May 11, 2017

Mr. Allan Berry, PE
Mr. Derrick Yates
City of Fairview
1300 NE Village St.
Fairview, OR 97024

Re: Review and Comments for *Ethylene Dibromide in Groundwater – Occurrence, Hydrogeology and Possible Sources*, by EVREN Northwest

FIGURE 1
Groundwater Capture Zones
for City of Fairview Production
Wells
 City of Fairview, Oregon

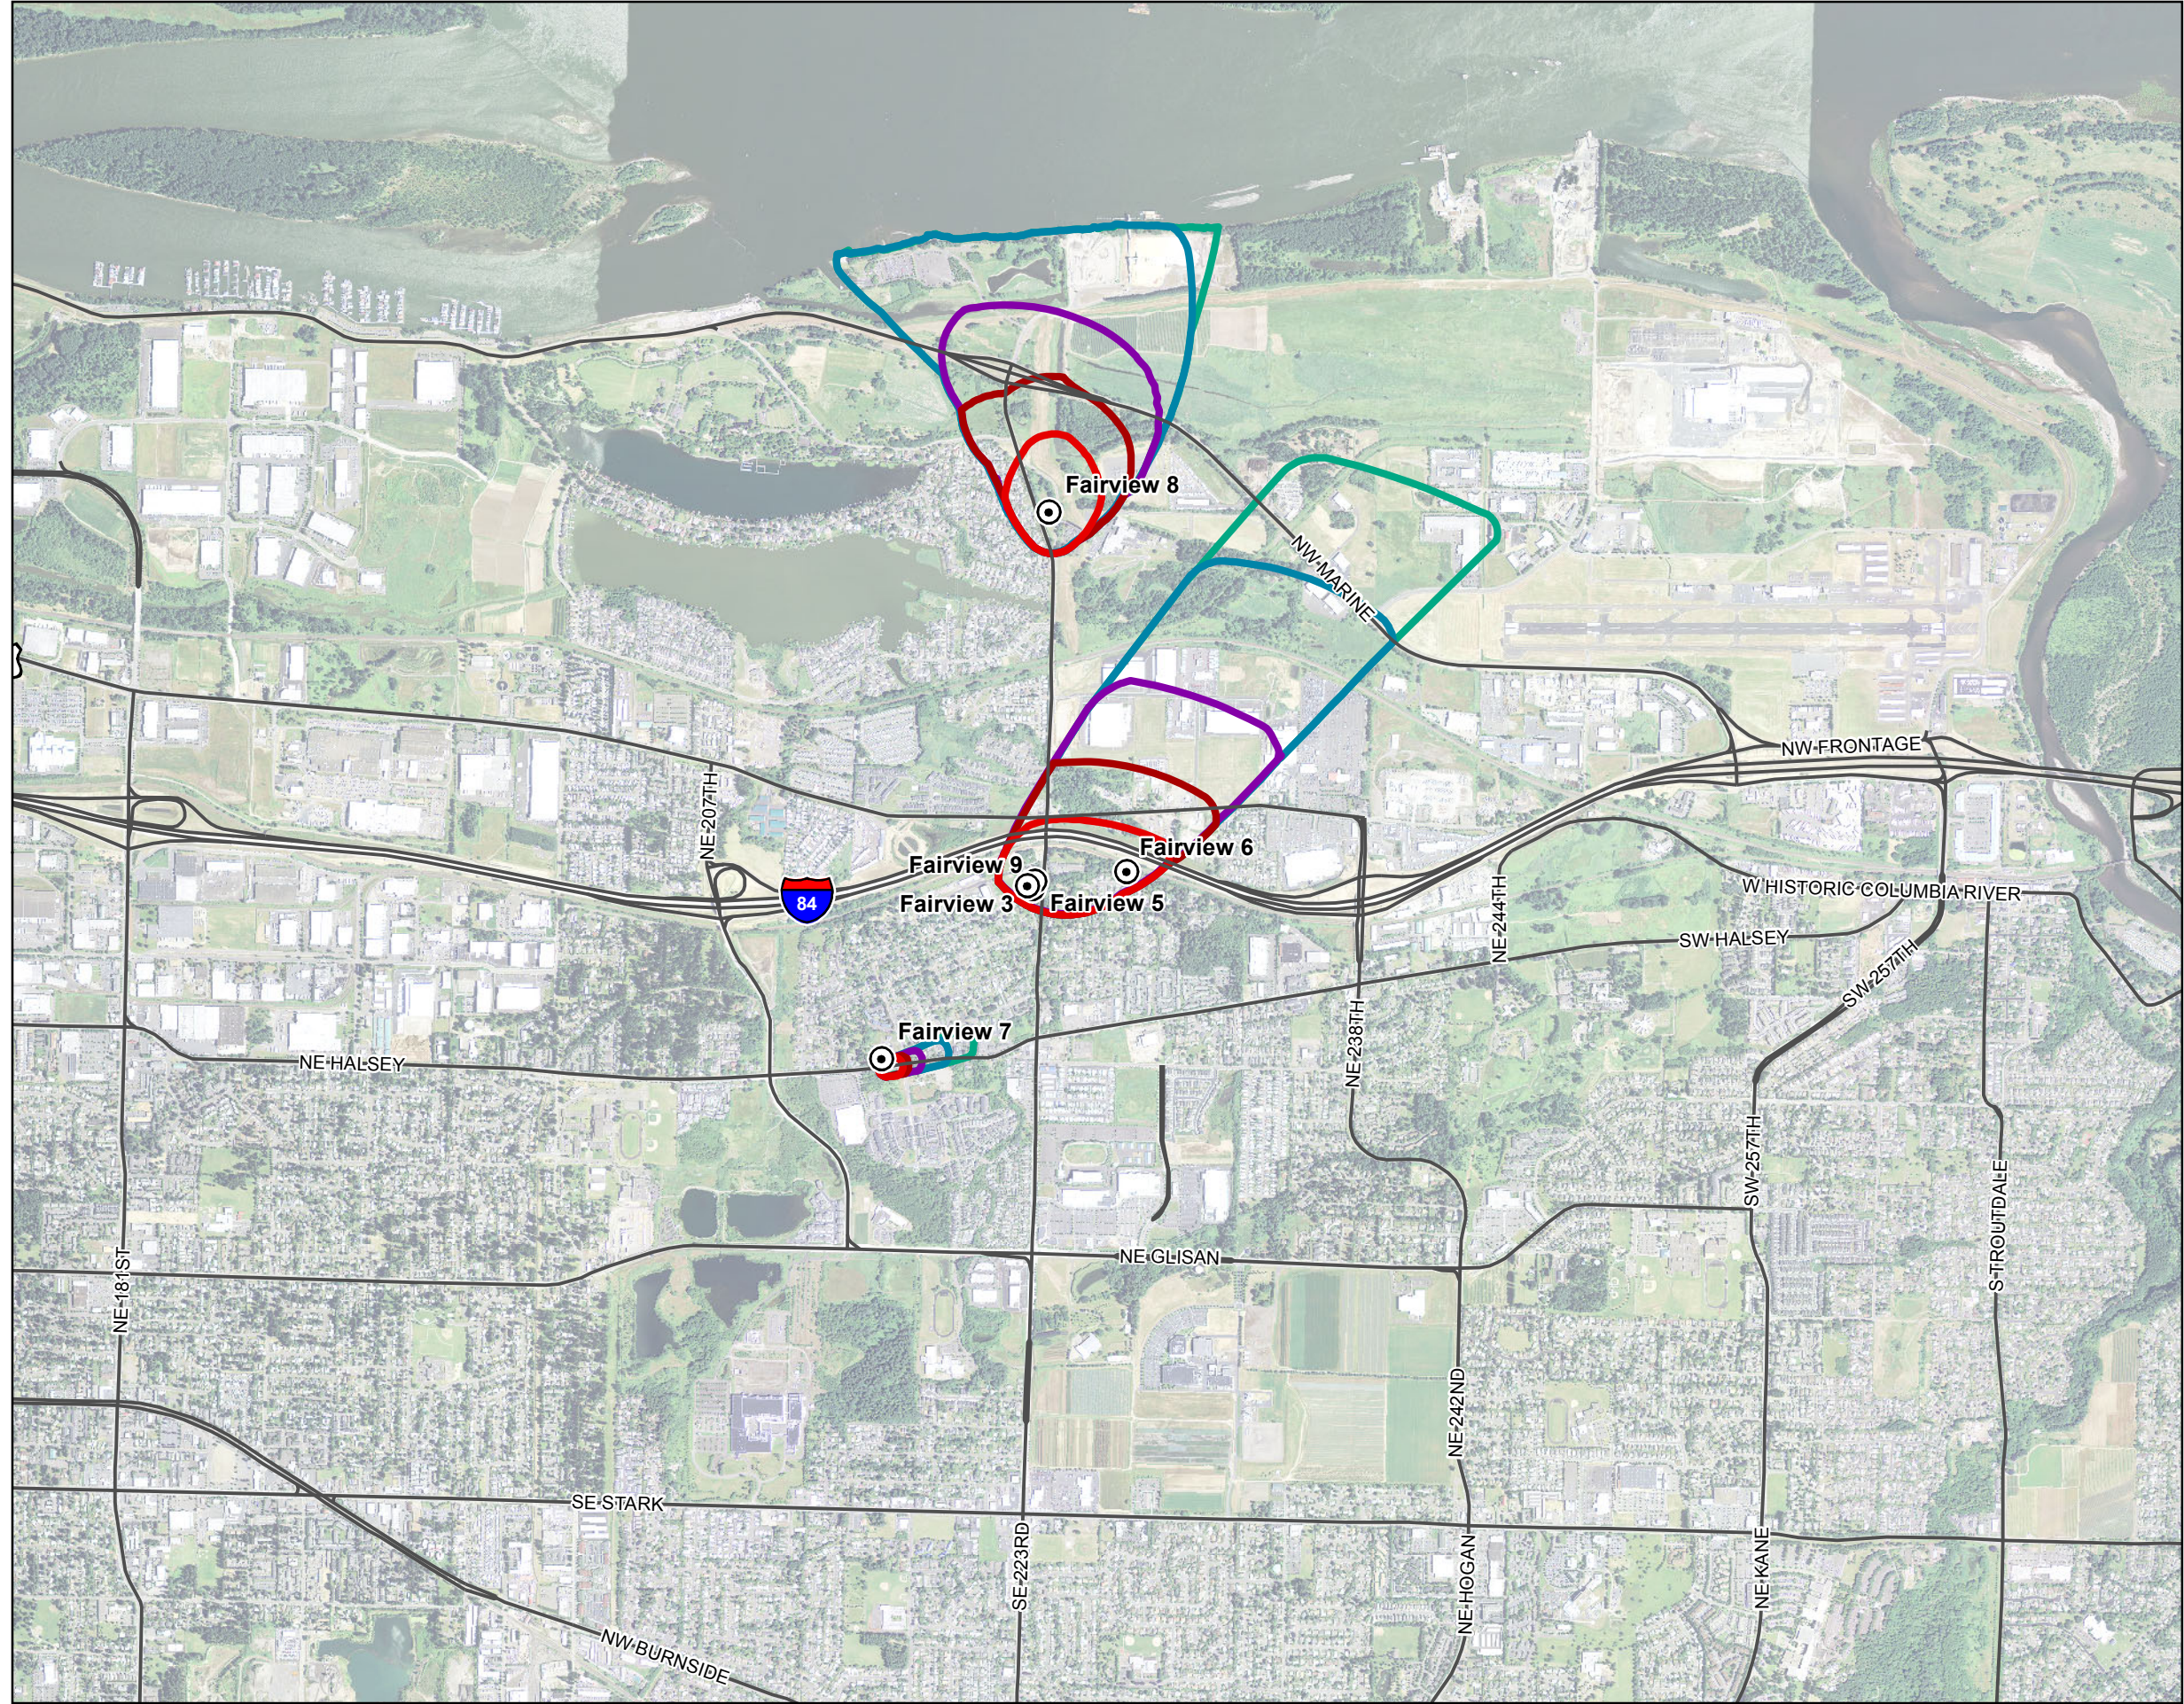
Attached are figures showing the capture zones delineated for the City's wells using the DAY Model. These delineations incorporate the effect of pumping of all other major SGA, TSA and BLA production wells, based on typical operational practices and production records obtained from each municipal entity. The capture zones delineated for the City's wells using the DAY Model show that the City's wells draw water from the north and northeast. Capture by City Well 8 is heavily influenced by the SGA connection with the BLA and Columbia River through the erosional window in

CU2. Capture by City wells 5, 6 and 9 is heavily influenced by the RWPUD/Gresham pumping center, located in the vicinity of NE 192nd and Halsey Street. Attached is a report (GSI, 2011) that summarizes the process and assumptions utilized in developing the capture zones delineated for the City's wells.

The capture zones utilized by ENW in its report were obtained from the DEQ Profiler site. These capture zones were delineated by the OHA DWP, likely utilizing an analytical model and imposed ambient south-to-north gradient; we surmise the gradient was assumed based on an earlier study, such as USGS Water Supply Paper 2470-A (1996). The model used by OHA DWP does not appear to incorporate major boundary conditions (e.g., the connection with the river), the influence of other pumping centers, nor the changes in the regional flow field over the past several decades. The resulting modeled capture zones are thus determined by the assumed regional ambient gradient imposed in the model and do not reflect the actual gradients present in the area since the late 1990s. The resulting capture zones suggest that all City wells primarily capture water from a southerly direction, which is highly unlikely. The City is in the process of providing the OHA DWP with the capture zones delineated with the DAY Model and supporting documentation, and will be requesting that these capture zones delineated by the OHA DWP be replaced by those delineated using the DAY Model.
